R1.1 TOWER WALL TYPOLOGIES

145 BROADWAY

DESIGN REVIEW RESPONSE NOVEMBER 22, 2016

AXONOMETRIC

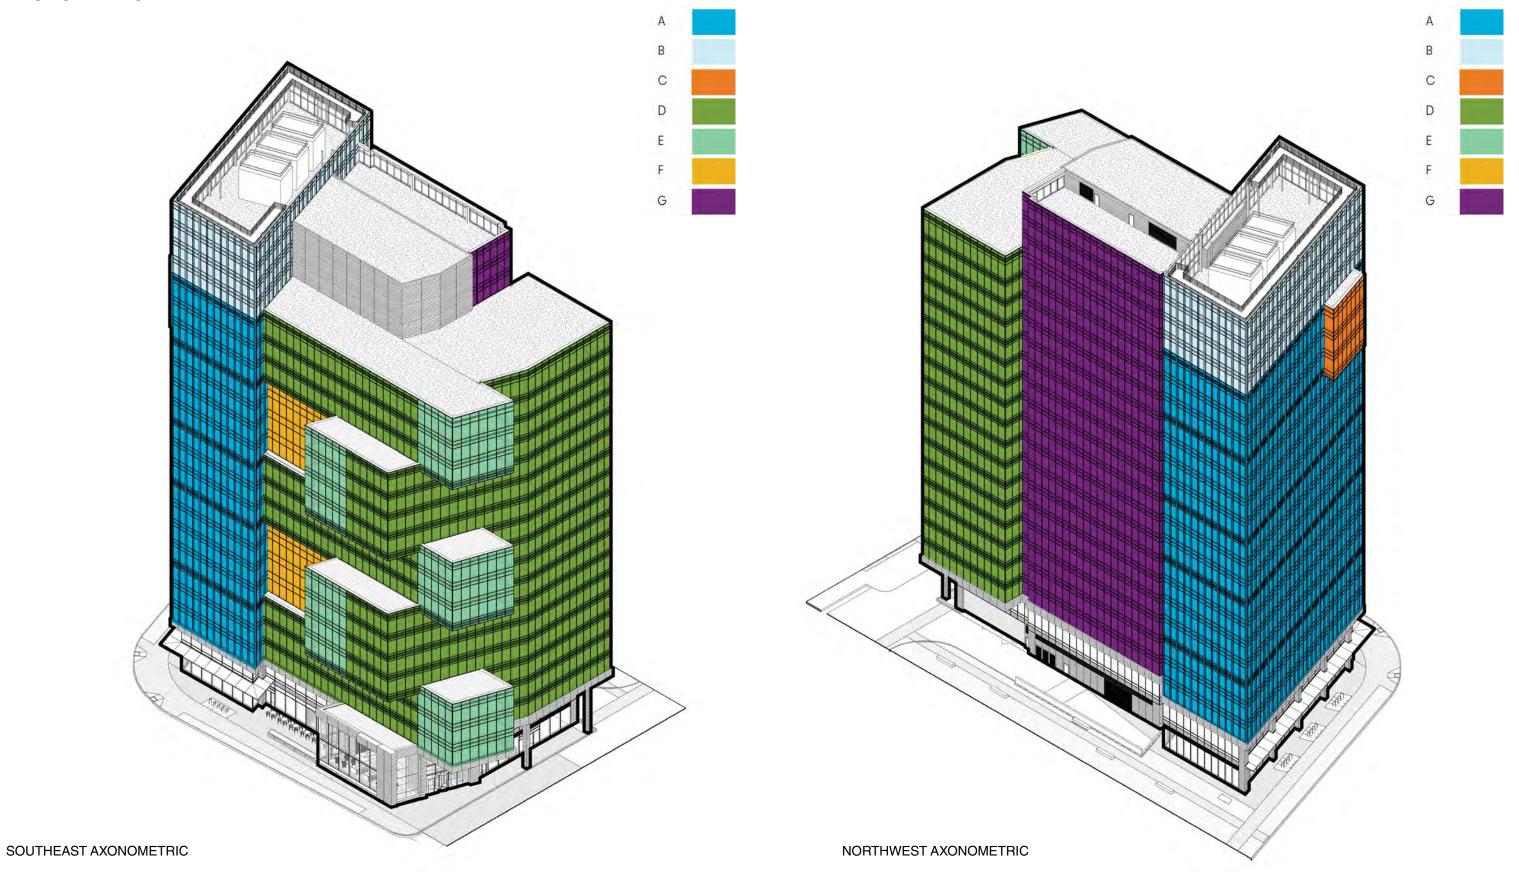
Applicant received comments that not all wall types were included in the initial Design Review submission and that the proposed wall types provided an overly complex composition. Section 1.1 presents a color coded Axonometric key of the proposed wall types with detail pages of each wall type including proposed materials, sections and renderings*. The tower wall composition has been simplified.

The following narrative explains the design intent for the wall type selection. The facade composition is divided into vertically articulated wall types located on the Western portion of the building and horizontally articulated wall types located on the Eastern portion of the building. This approach adds a human scale to the tower form. While there are slight and deliberate variations within these basic organizations, the overall concept emphasizes the contrast between the vertical Western form, that anchors the corner, and of the more intricate, horizontal Eastern form, that responds to the Park. The following detailed explanation of each wall type explains the design intent of each specific type.

R1.1.1 **WESTERN TOWER WALL**

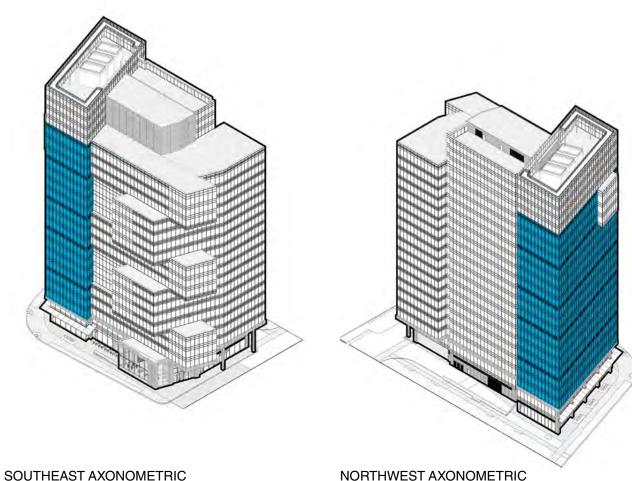
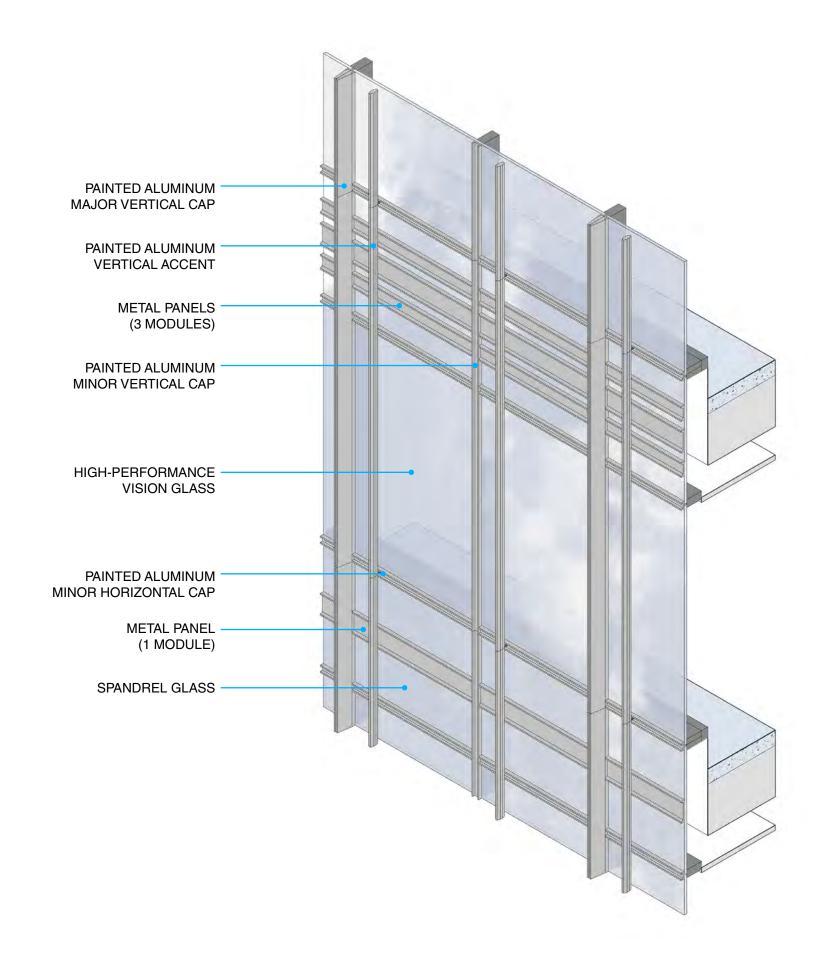
Western Tower Wall - Type A (1.1.1) – Wall Type A is concentrated on the Western tower portion of 145 Broadway shown in dark blue on the Axonometric key. The fenestration features details consistent with the verticality of the western volume and with the intent to emphasize a marked gateway. The wall has the same glass composition and horizontal aluminum as the horizontal wall types so that there is a consistent relationship across the building but features distinct vertical aluminum caps and vertical aluminum accents to contrast the eastern horizontal portion of the building and to provide visual interest from the street.

R1.1.2 **WESTERN PENTHOUSE WALL**

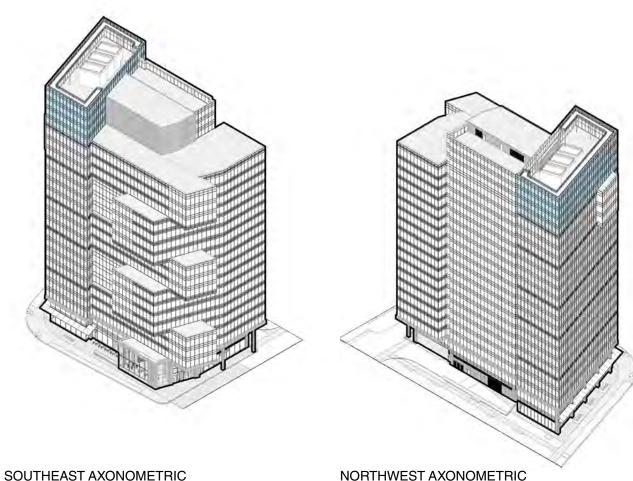
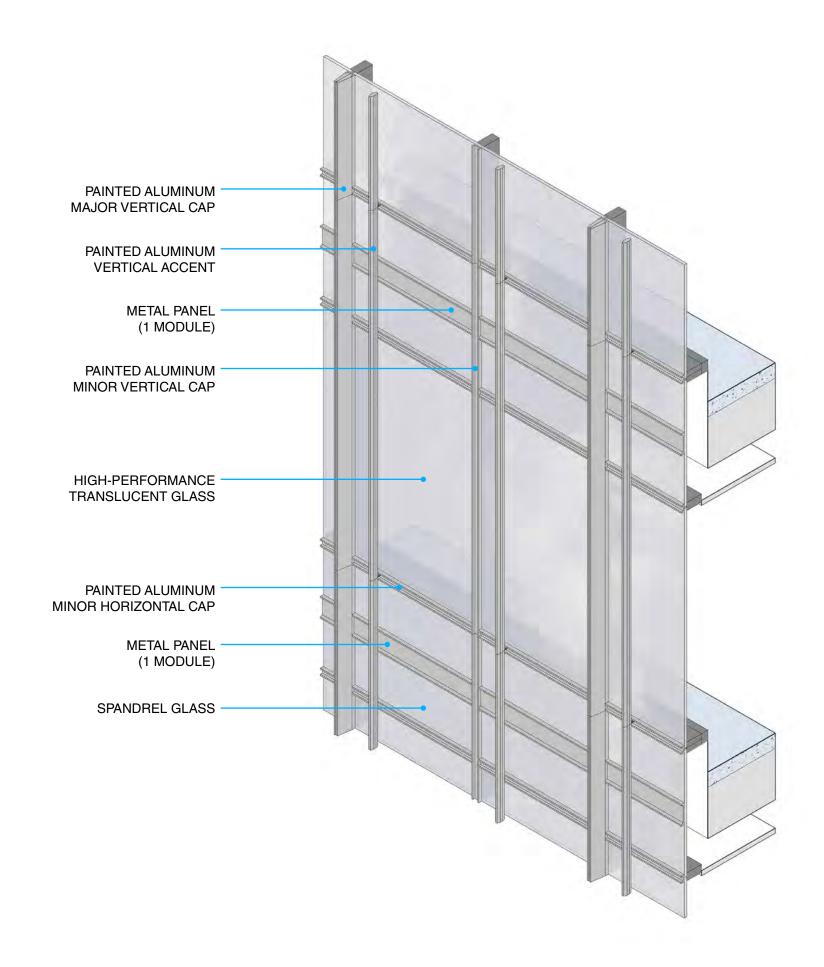
Western Penthouse Wall - Type B is concentrated on the Western penthouse portion of 145 Broadway shown in light blue on the Axonometric key. Wall Type B is essentially the same as Wall type A with the exception of the glass and omission of the horizontal painted aluminum. This section of wall is intended to screen the mechanical equipment so the glass will be translucent, creating a distinct top and enabling the possibility to explore lighting in conformance with the future potential lighting ordinance. The three painted aluminum horizontal bands have been removed but the vertical caps and accents continue in this section to provide visual continuity across the entire western volume and mark this section of the building as the gateway.

R1.1.3 **WESTERN TOWER PROJECTION WALL TYPE C**

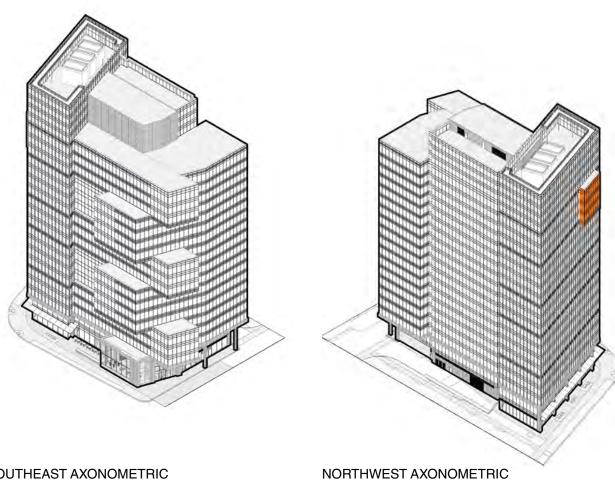
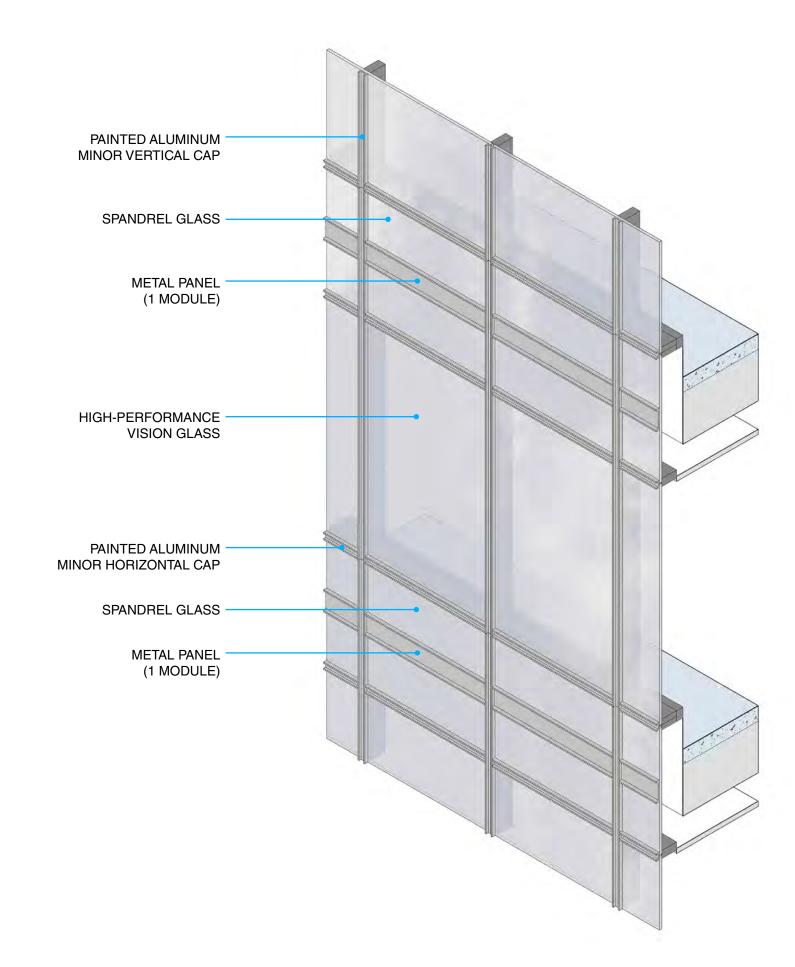
Western Tower Projection – Type C (1.1.3) – Wall Type C is located in the projection in the upper Western tower portion of 145 Broadway shown in orange on the Axonometric key. Wall Type C is the same as a portion of the horizontal wall types described below consistent with the intent to have one of the elements from the eastern volume protrude or join the Western volume. The projection is an important joining element that unites the eastern and western massing; accordingly the wall type will relate to the eastern wall types.

R1.1.4 EAST TOWER WALL

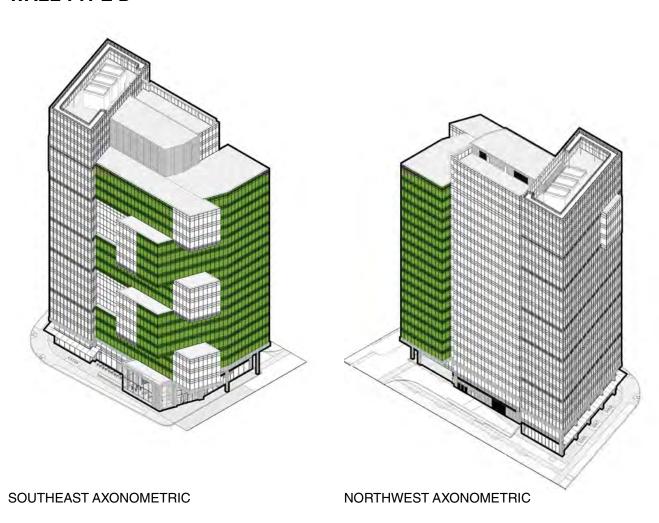
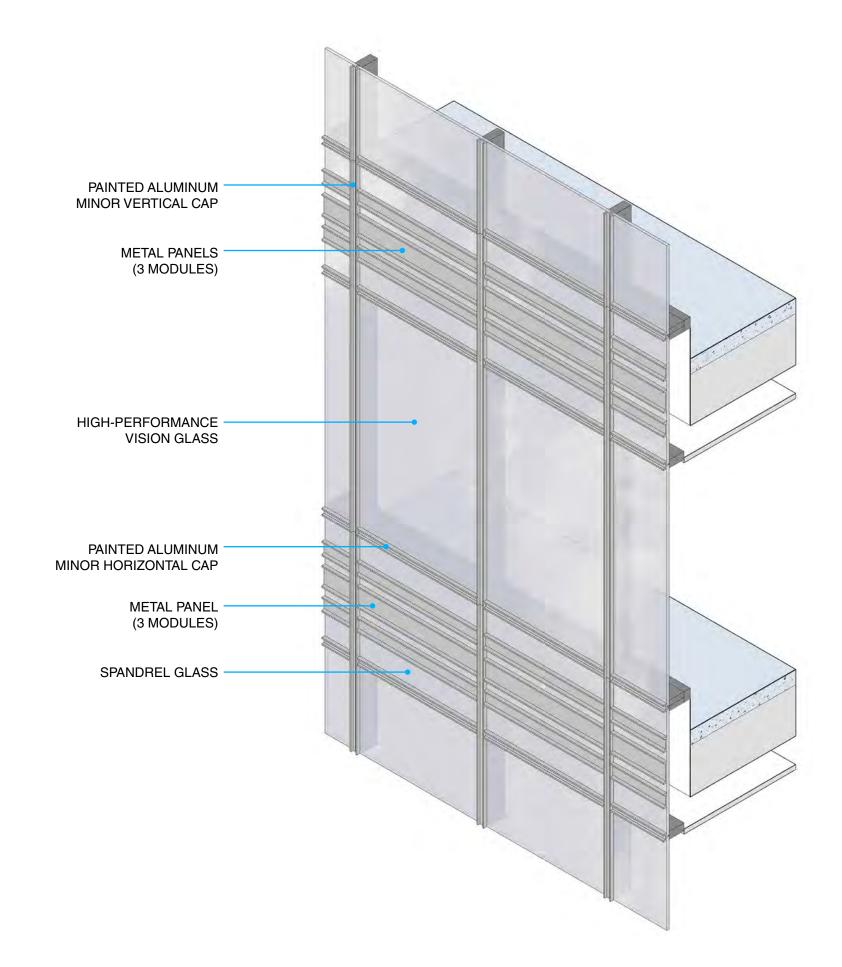
East Tower – Wall Type D (1.1.4) - Wall Type D is located on the majority of the South and Eastern facades of the eastern Portion of 145 Broadway. Wall Type D is horizontally oriented and is shown in dark green on the Axonometric key. Wall Type D features glass and painted horizontal aluminum bands but does not include the vertical caps or vertical aluminum accents as the Wall Types A and B.

R1.1.5 EASTERN JOINERY

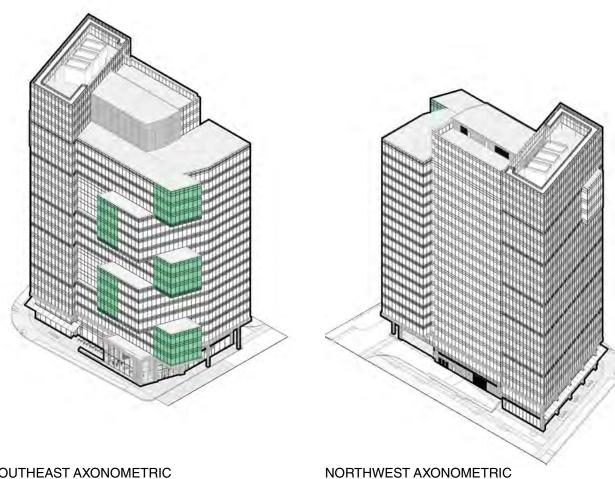
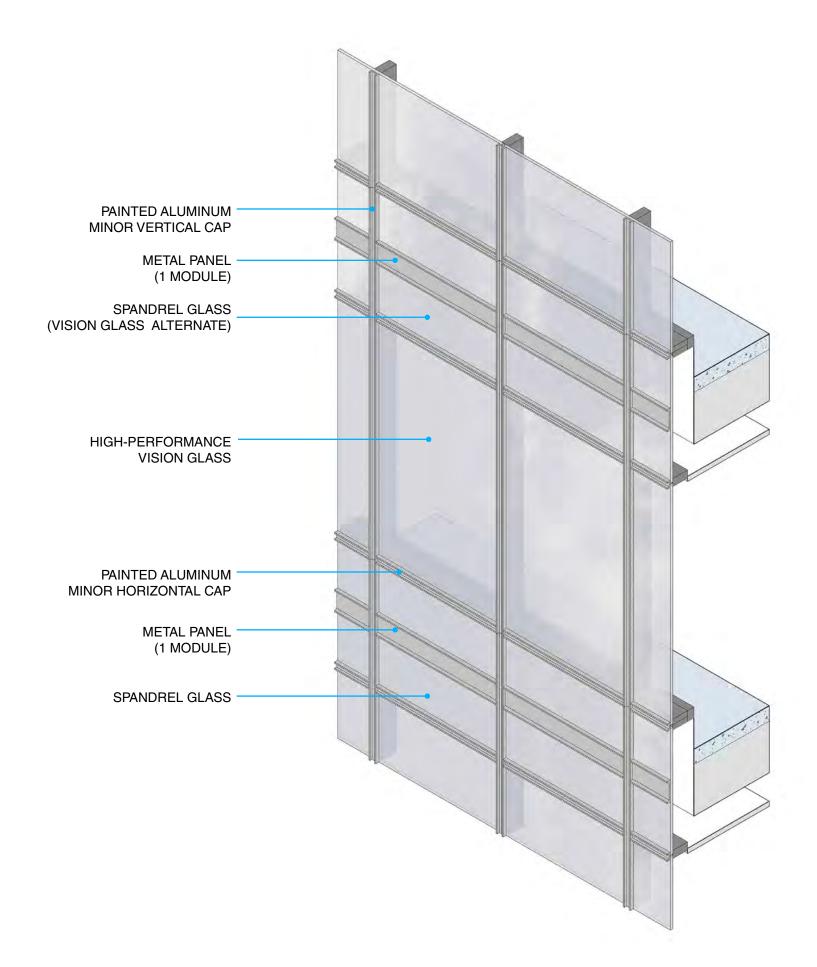
Eastern Joinery – Wall Type E is located at the ends of the joinery pieces in the southeastern corner of 145 Broadway shown in light green on the Axonometric key. Wall Type E is designed to be glassy, light and transparent to help accentuate the impact of the southeastern joinery pieces and provide enhanced visual connectivity with the street. The glass composition is the same but instead of a spandrel panel, these sections feature additional vision glass and do not include any vertical accents and only include 1 aluminum horizontal band. Whether the interior spaces ultimately become atria or not is a tenant driven decision based upon internal space programming. However the spaces have been designed to easily accommodate this purpose.

R1.1.6 **SOUTHERN RECESSED**

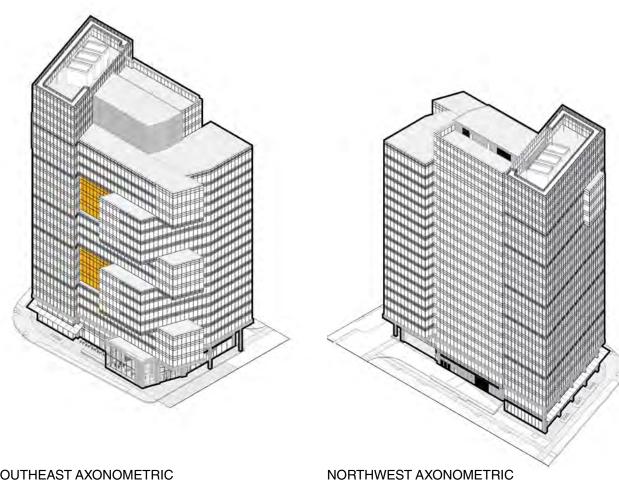
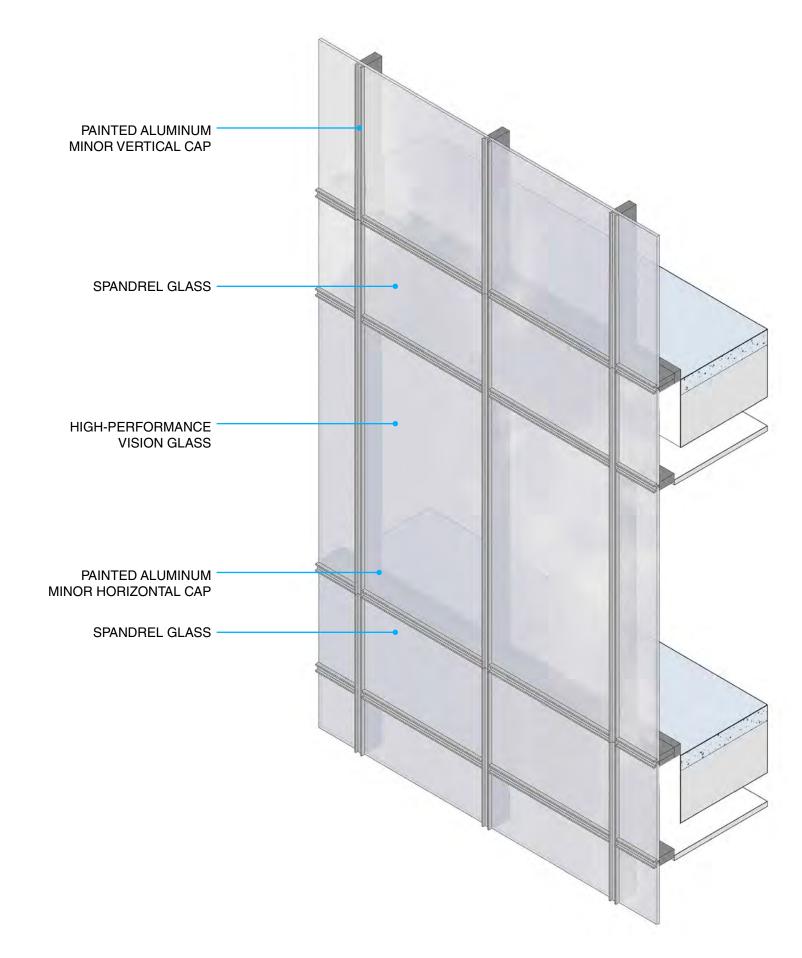
Southern Recessed Tower – Wall Type F is located only on the recessed portions of the southern wall as shown in yellow in the Axonometric key. Wall Type F is designed to be glassy and simple to help distinguish the volume from the joinery pieces above and below and reinforce the expansion and contraction found throughout the building. The wall is designed to be glassy and minimal to present a clean and continuous glass plane.

R1.1.7 **NORTHERN WALL**

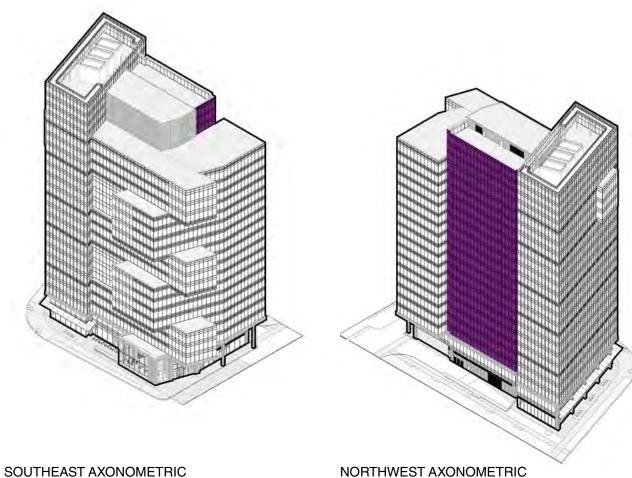
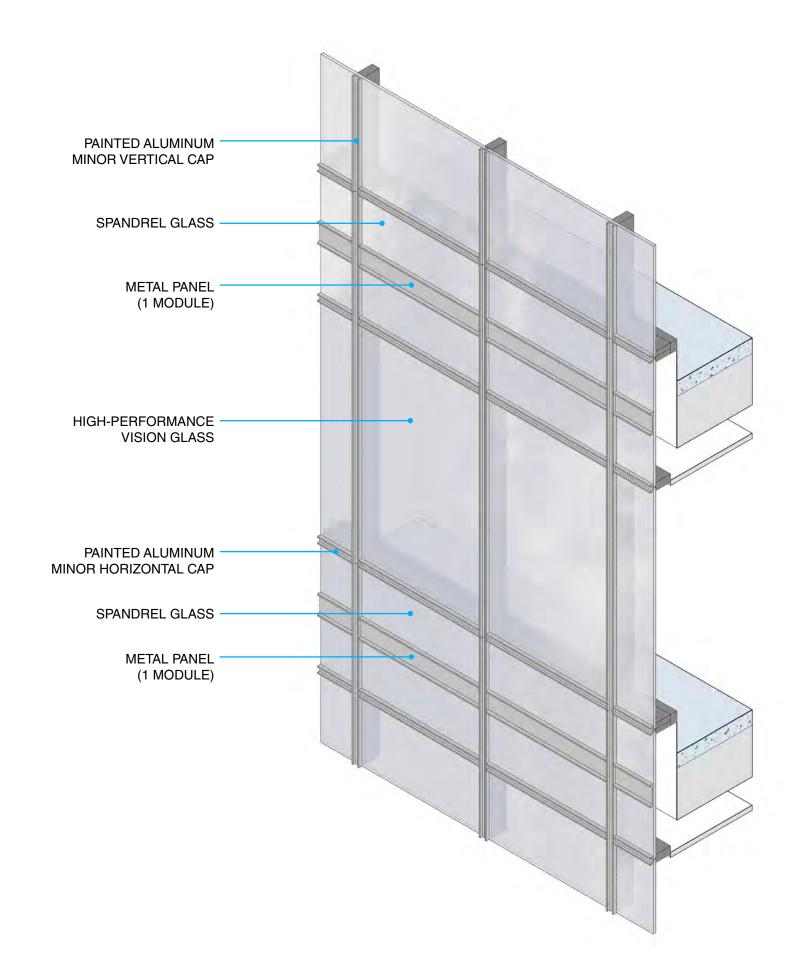
Northern Wall – Wall Type G (1.1.7) - Wall Type G is located on the Northern portion of the building as shown in purple on the Axonometric key. It is the simplest wall type that is recessed from, and stands in contrast to, the adjoining vertically oriented wall type A to the west and Wall Type C to the East. The massing also features two reveals that help distinguish how these wall types meet on the Northern facade. The intent is to provide a neutral space between the two principle, contrasting, vertical and horizontal wall types.
